City of Willow Park
Planning & Zoning Commission
Regular Meeting
516 Ranch House Rd. Willow Park, TX 76087
Thursday May 16th, 2019 6:00 pm
Agenda

Consider and act on a revised Site Plan for a hotel in the PD Commercial/IH-20 Overlay District on Lot 12R, Block B, Crown Pointe Addition located at 338 Shops Blvd.

SHEET
C2.0

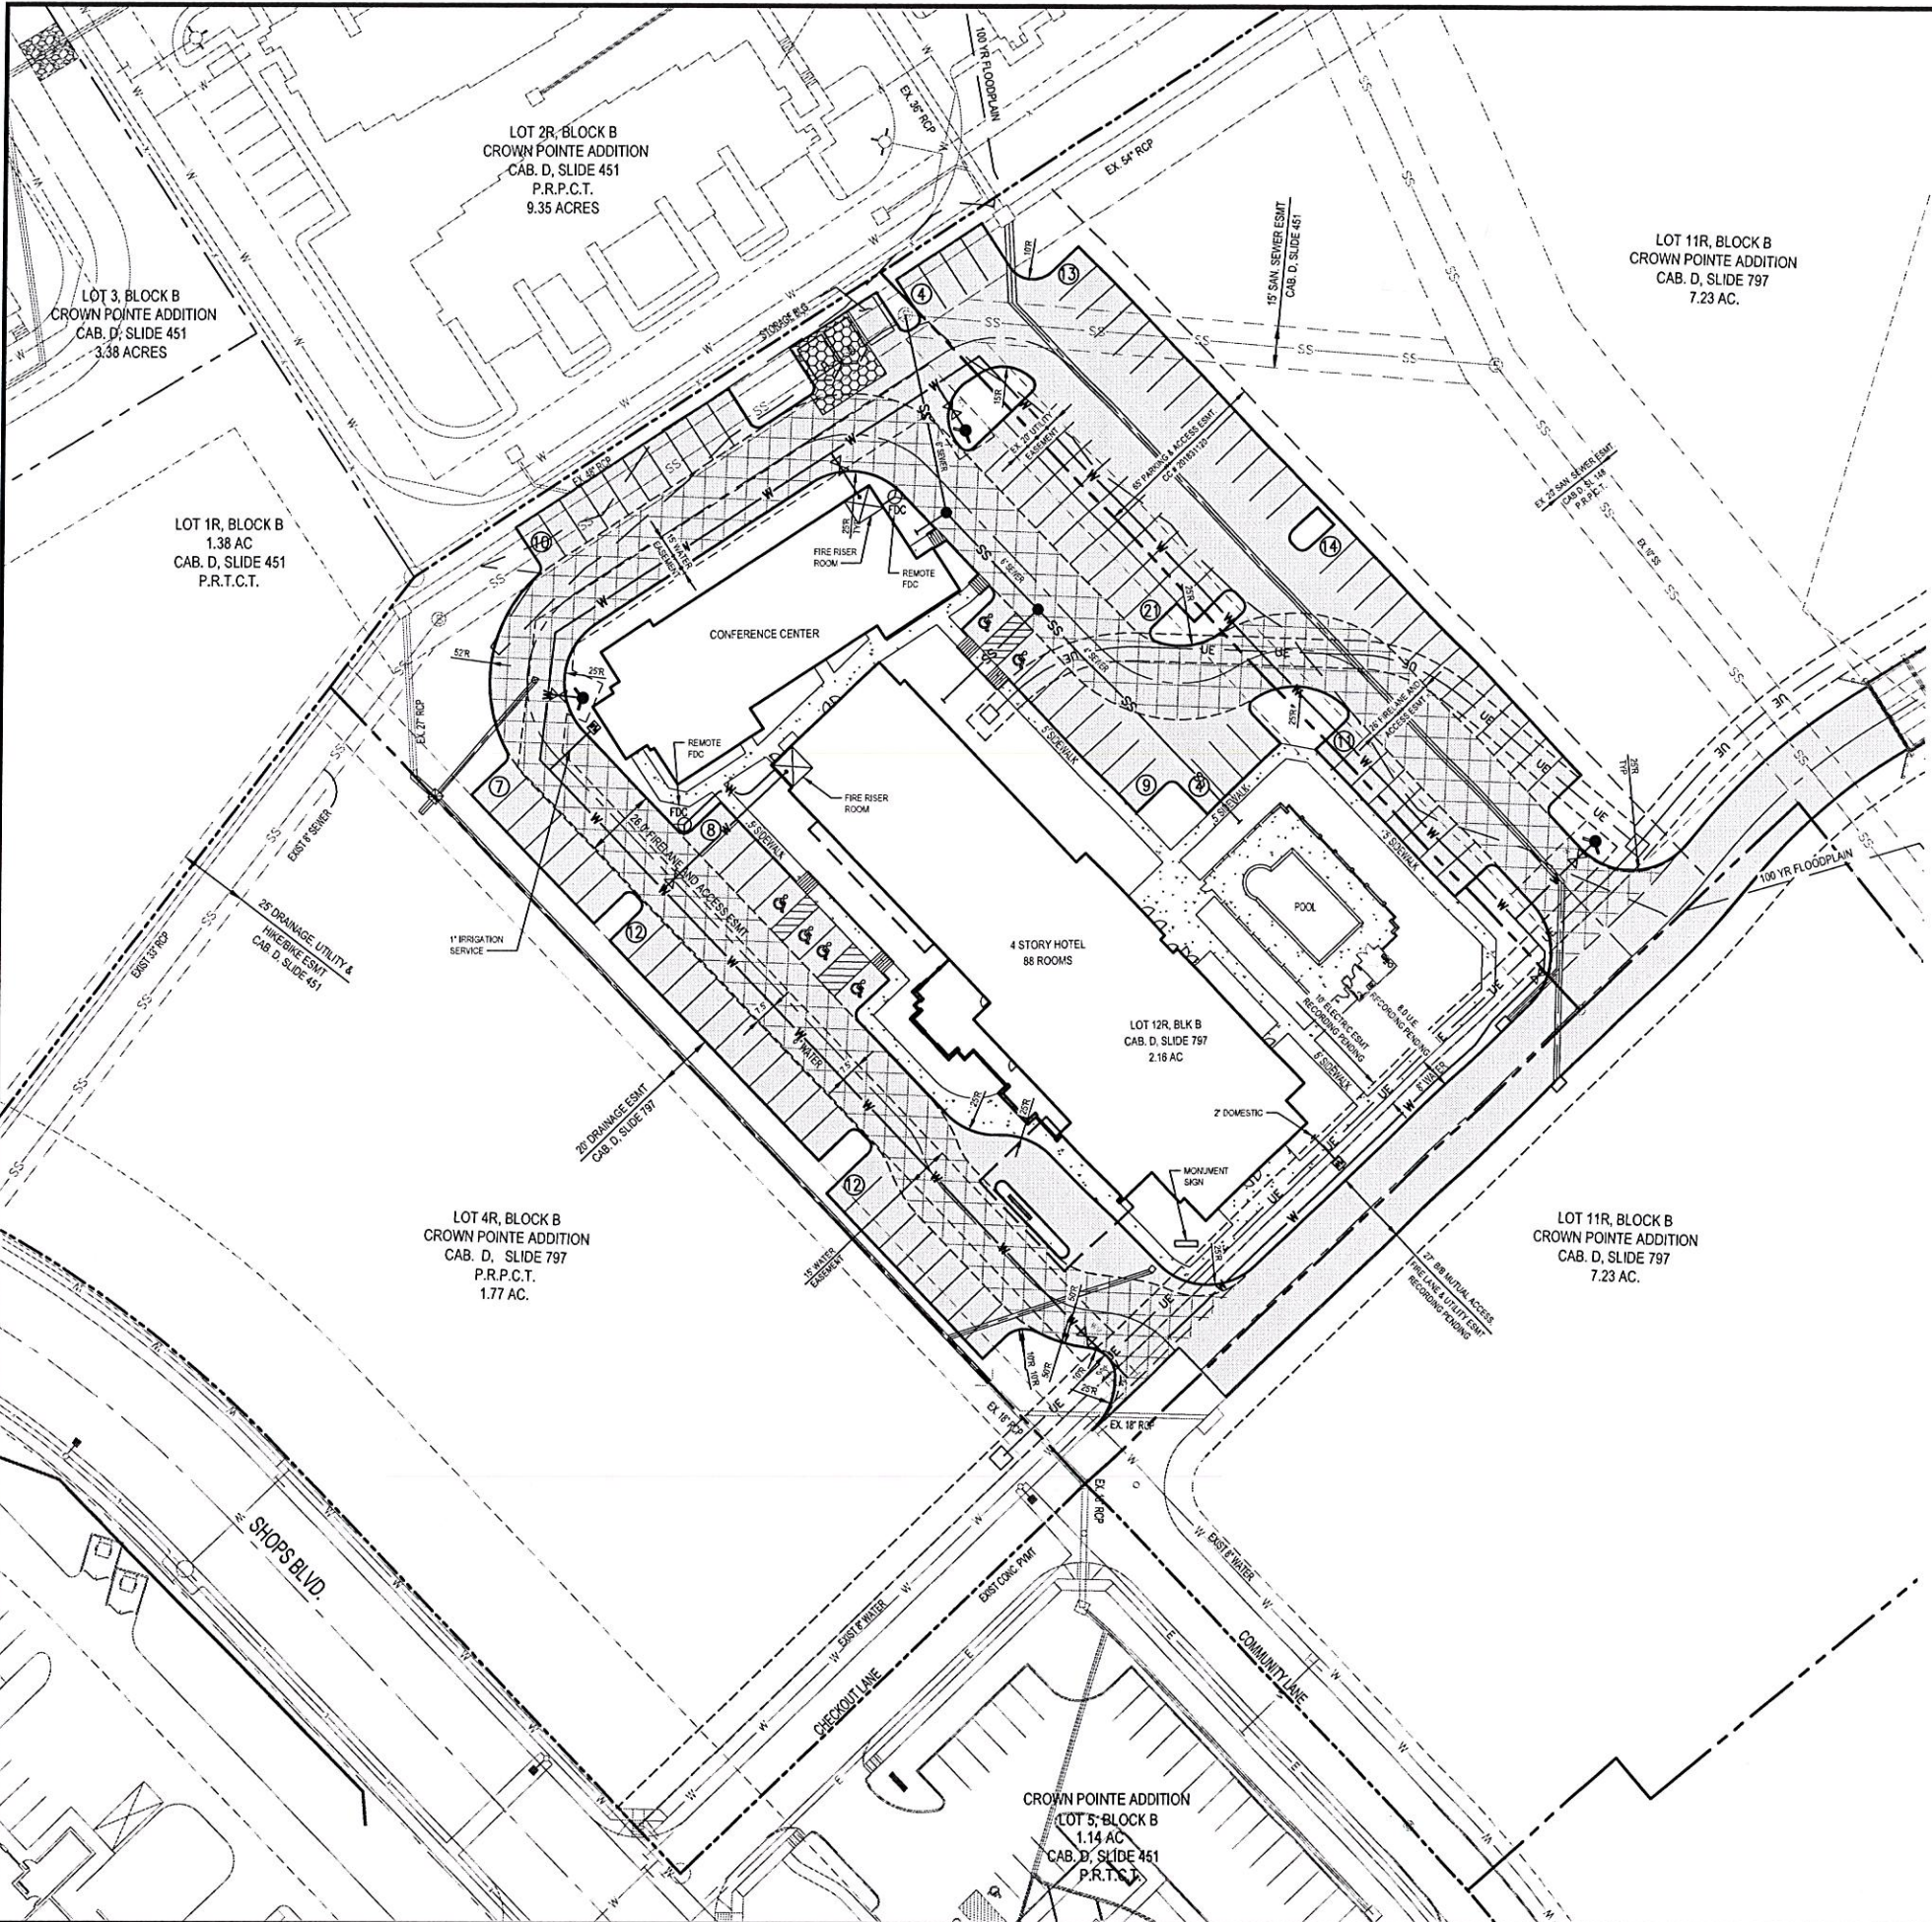
Staff recommends approval of the Site Plan for Lot 12R, Block B, Crown Pointe Addition, as revised, with the following required for final approval:

1. Stormwater drainage study and drainage improvement plans required.
2. Finished floor elevations required for structures in 100 year flood plain.
